# Town of Ashland

## 9-49 Homer Ave

### Design Review Committee Report #3

Meeting date: October 5, 2023

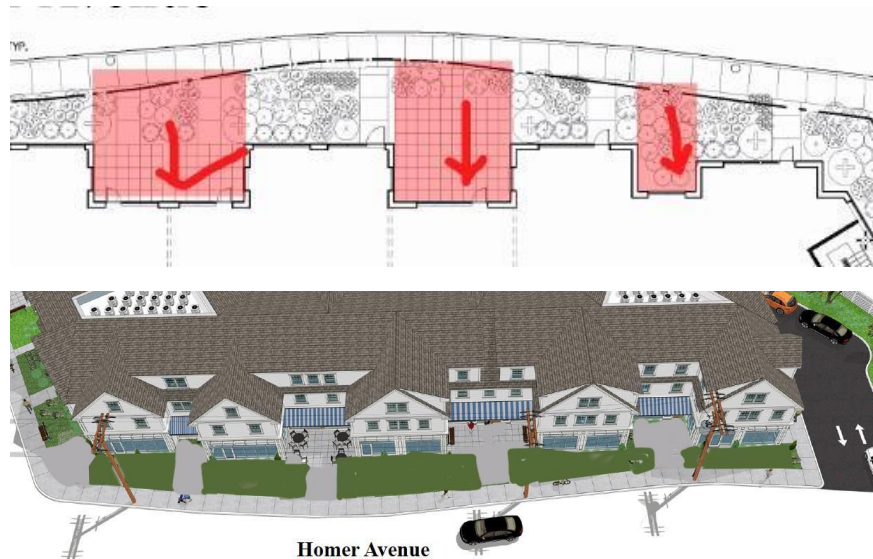
Action items are in **red** throughout this document are a record of action items.

Items in **green** were received by the Planning Board as comments on Report #2.

Report #3 items are dated 10.5.2023 and colored in **blue**. Current recommendations to Planning Board are in **blue bold**.
